No. 86-17

- A. Borg Warner Gear Ratio Change
- B. Thunderbolt IV HEI Amplifier Identification
- C. Running MerCruiser Engines on Shipping Skids

Figure 1. Amplifier Identification

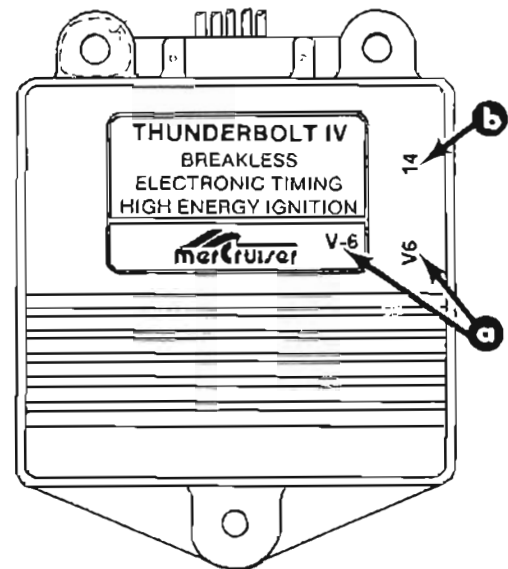
Starting in August of 1986 General Motors will introduce some design changes to the 305 CID and 350 CID blocks. The design changes will incorporate a new cylinder head and different spark advance curves. Because MerCruiser's Thunderbolt IV HEI ignition spark advance is controlled by the ignition amplifier there will be several different versions used. Care must be exercised not to use the wrong amplifier on an engine as poor performance or engine damage may result. Amplifiers will be identified by engine type and degrees of spark advance the amplifier is set for (figure 1).

Amplifiers marked V-6 14 will fit all 262 CID V-6 engines. Amplifiers marked V-8 24 will fit all 454 CID V-8 engines and all 305 and 350 CID engines prior to

the new cylinder head change. Amplifiers marked V-8 22 will fit the 305 and 350 CID engines with the new cylinder head. A future bulletin will be issued with starting serial numbers for engines with the new cylinder heads when this information is available.

a - Engine Model
b - Degrees of Spark Advance
